## National Highways Planning Response (NHPR 22-12) Formal Recommendation to an Application for Planning Permission

**Council's Reference: PA/2023/421**

**Location: VPI Power Station, Rosper Road, South Killingholme, DN40 3DZ**

# AA.23.19.26 VPI Carbon Capture Facility, Rosper Road, South Killingholme

Figure 2. VPI Staff Traffic Distribution

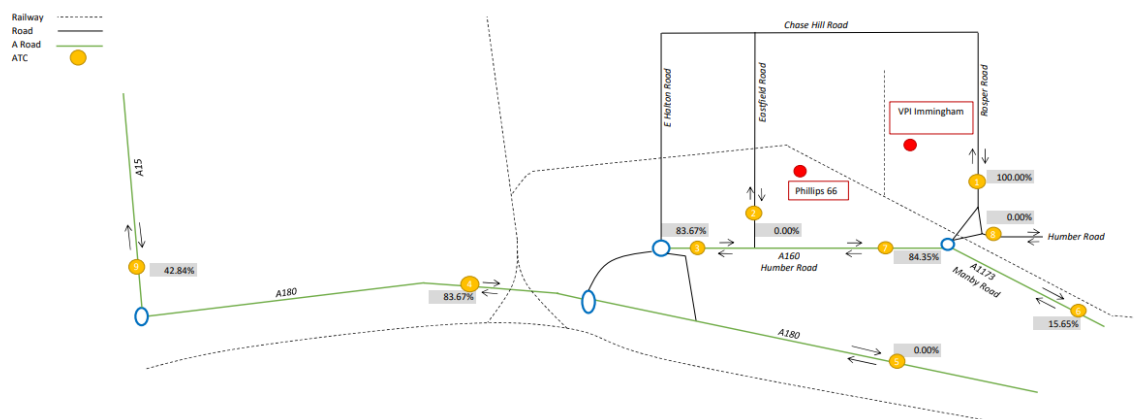
It is noted that a gravity model, based on population, has been utilised to derive a traffic distribution for staff and this was agreed in advance with the LHA. The distribution is presented in **Figure 2** for reference. As can be seen, 100% of trips are forecast to route via Manby Roundabout.

Figure 3. VPI HGV Traffic Distribution<sup>2</sup>

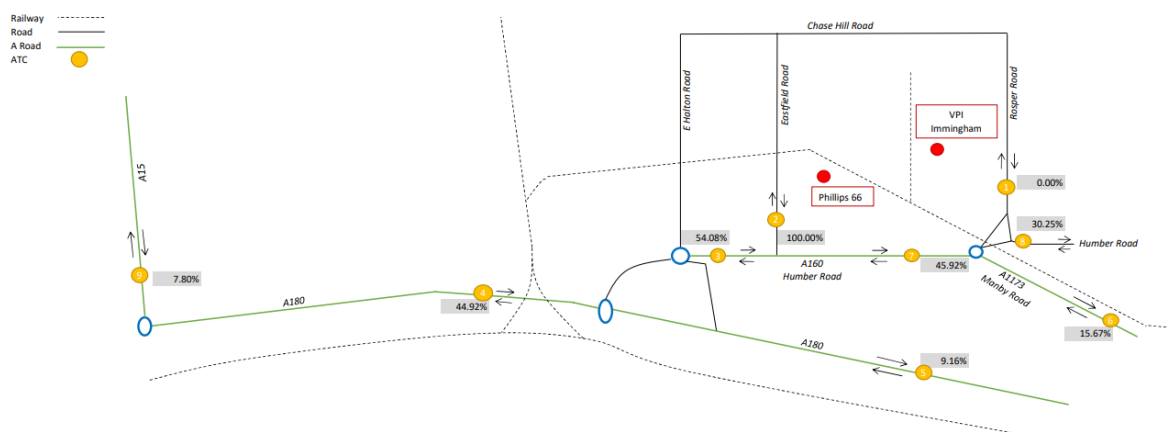
The HGV distribution [**Figure 3**] was derived using a methodology based on HGV trips recorded at WebTRIS and DfT counters. As can be seen, over 75% of trips are forecast to route via Manby Roundabout.

Figure 5. Construction Worker Profile<sup>5</sup>

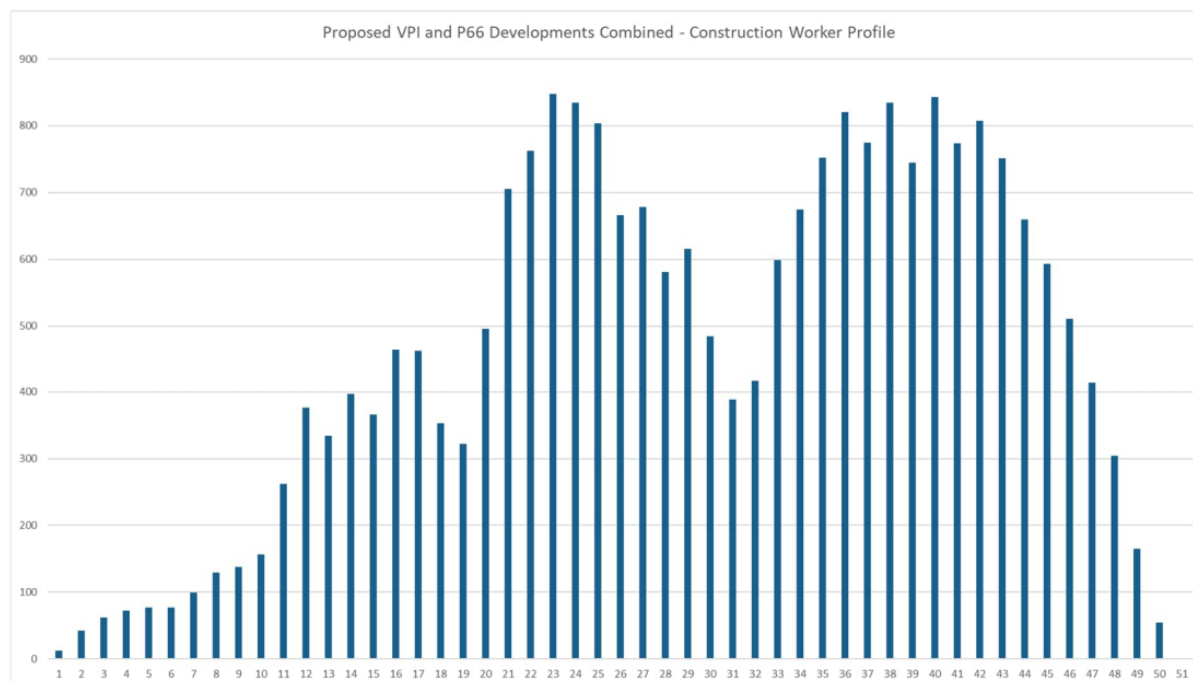
The CWTP presents a combined construction worker profile for the Phillips 66 and VPI proposed developments [**Figure 5**]. As can be seen, a cumulative total of approximately 850 construction staff is expected during the peak construction periods. We note that these forecasts are not consistent with those presented in the CTMP and clarification should be provided.
